## Product Change Notification

### MultiTech Conduit® Programmable Gateway

PCN 01272022-001 (Conduit - mPower)

2. **Hardware Version:**

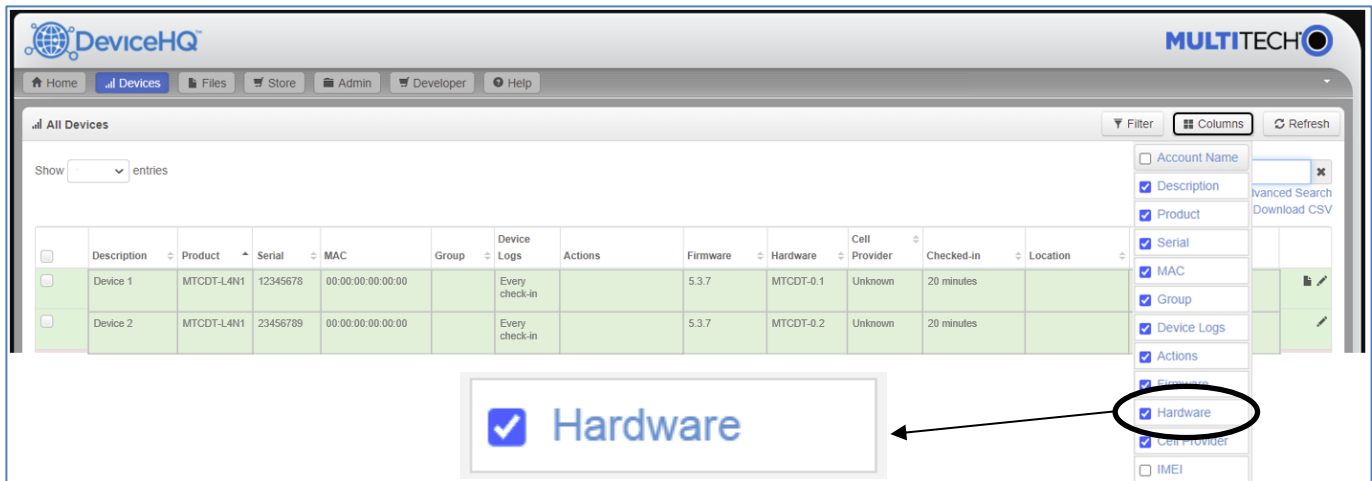
- MTCDT device with original components – Hardware Version “MTCDT-0.1”
- MTCDT with substitute components – Hardware Version “MTCDT-0.2”

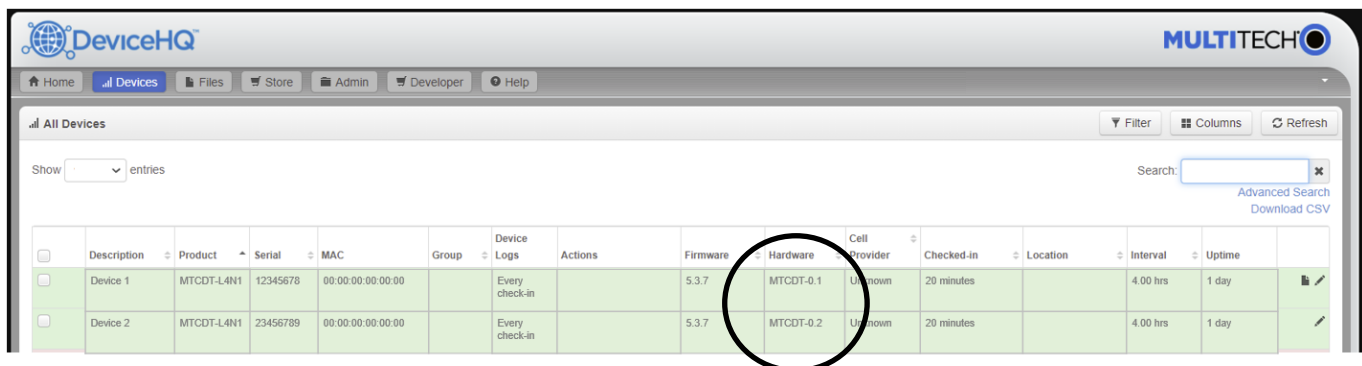
Once this selection is made, the DeviceHQ dashboard will show the hardware version of each device:

- **MTCDDT-0.1** - MTCDDT device with original components
- **MTCDDT-0.2** - MTCDDT with substitute components

### Changes to Debug Connector and Cable

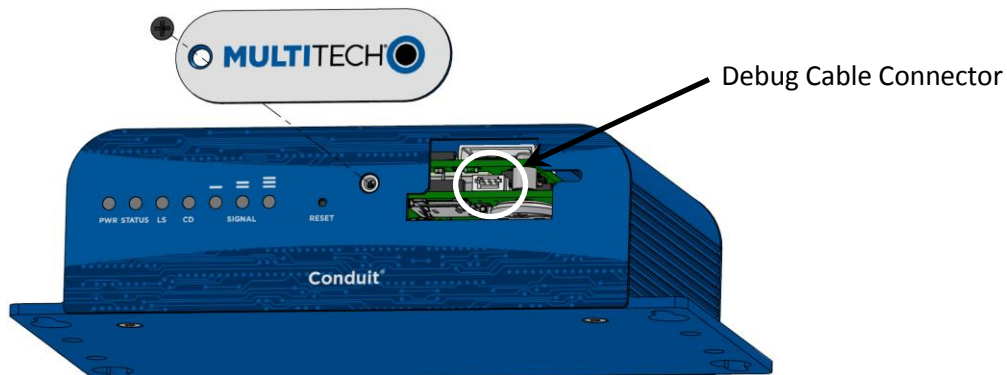
The debug cable connector is located behind the MultiTech nameplate on the Conduit device. Using this connection, the host device has access to the Conduit USB COM port.

The current debug cable connector is a standard USB Micro B Connector. This connector has been available on Conduit devices for several years. A standard USB A-Male to Micro B cable is used to connect a host device to the Conduit.

Conduit devices with substitute components will ship with a custom 3-pin cable connector:

- A new 3-pin connector is used in place of the USB Micro B connector
- A custom USB A-Male to 3-pin connector cable is needed to connect a host device to the Conduit
